**MCPB**  
**Item #3**  
**7/29/10**

**MEMORANDUM**

**REVIEW TYPE:** Preliminary Plan of Subdivision

**PROJECT NAME:** Brooke Park  
**CASE #:** 120080190  
**REVIEW BASIS:** Chapter 50, Montgomery County Subdivision Regulations

Exhibit C: Preliminary Plan

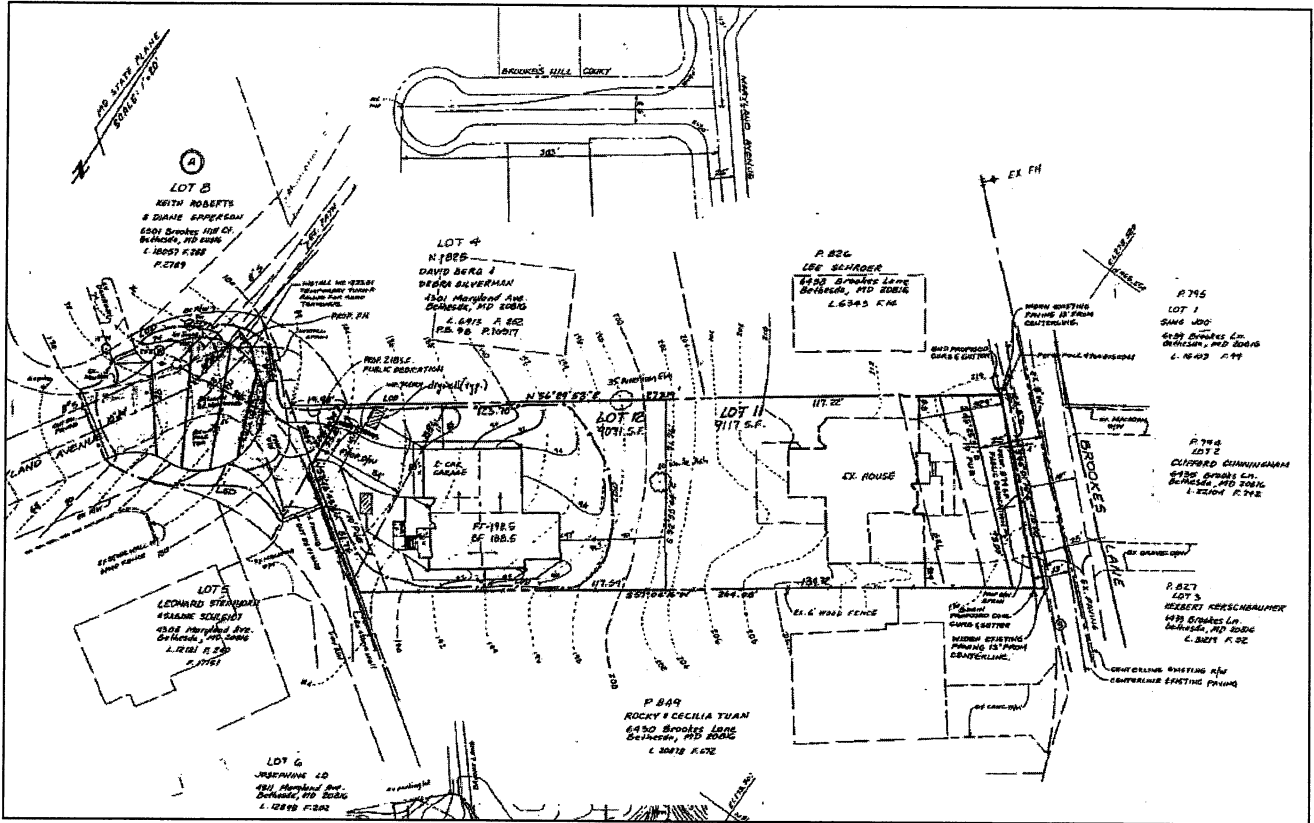
The Applicant proposes to subdivide the Property and record 2 lots for 2 one-family detached dwelling units. The existing house is shown to remain on proposed lot 11, which will be 9,117 square feet. Right-of-way dedication for Brookes Lane is provided along the frontage of lot 11, so that 25 feet of right-of-way from the centerline would be dedicated. The existing house, which was built to the zoning standards in effect when the existing parcel was created, will not meet the side setback requirements for R-90 zoned lots (8.2 feet short on one side) or the front setback requirement (5 feet short), but would be permitted to remain as a nonconforming structure. A new dwelling unit is shown on proposed lot 12, which will be a 9,071 square foot lot. Approximately 218 square feet of right-of-way dedication is proposed for Maryland Avenue in the southwest corner of the Subject Property, located tangent to a proposed cul-de-sac. As a result of this dedication, lot 12 is proposed to have 25 feet of frontage on Maryland Avenue. The Montgomery County Department of Transportation and the Montgomery County Fire Marshal's office have accepted future construction by the Applicant of a sub-standard cul-de-sac with a 50 foot diameter cul-de-sac bulb as an acceptable means to accommodate emergency, service, and

other vehicle turnaround movements. A number of significant and specimen trees are affected by the existing and proposed construction impacts.

**Staff/Agency response:** The Department of Permitting Services has found that lot width can be measured parallel to the right-of-way dedication line, or tangent to the cul-de-sac. As a result, the proposed widths meet the Zoning Code requirement of 75 feet in the R-90 zone. Staff does find that the application fails to comply with Sections 50-29(a)(1) and 50-2(a) of the Subdivision Regulations.

Exhibit E: Tree Save Plan

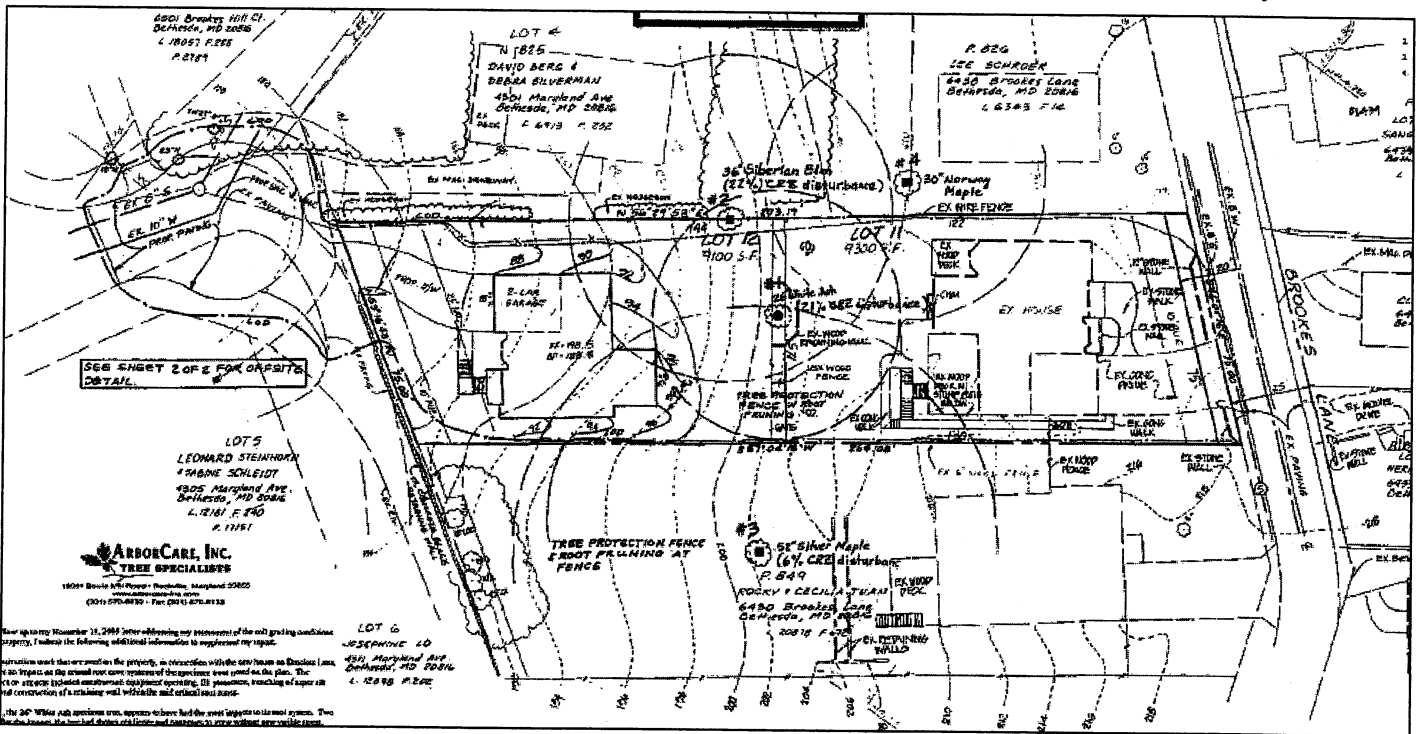
demolished and then re-constructed the home without submitting or receiving approval of the required Tree Save Plan, constituting a violation. The ultimate limits of disturbance (LOD) used for the construction activity far exceeded the LOD shown on the conditionally approved exemption. Photographs and site visits have confirmed that a sediment control fence had been trenched immediately upslope of the 26" ash (tree #1). A retaining wall with substantial fill has been constructed very near the same tree. The Sediment control fence was later removed and reset (also with trenching) in close proximity to the 36" Siberian elm (tree #2). A layer of fill has been placed approximately 1 to 3 feet deep on the subject property throughout the Critical root zones of trees #1 and 2 in addition to the offsite 52" maple (tree #3). The LOD for the work encompassed approximately 80% of the site (the conditionally approved exemption showed approximately 40% disturbance to the site, with work located away from the larger trees). The proposed development of the site will include the previously undisturbed areas, causing nearly 100% disturbance to the Subject Property.

The violation of the previously approved exemption became apparent to staff when the subject application was filed. A determination was made at that time, to address the impacts to existing trees, and any necessary mitigation/replacement, as part of this application. The arborist report and recently submitted tree save plan, pictured on the following page, reflect that the 26" ash tree has been resilient and is not yet showing signs of stress. However, the 36" elm is currently

showing die back in its canopy. The arborist has recommend treatments and further monitoring and assessment of the declining elm tree. Based on the recommendations of the arborist, Environmental Planning staff is prepared to approve a tree save plan that would include conditions for replacement of trees if the measures taken to save the trees are not successful.
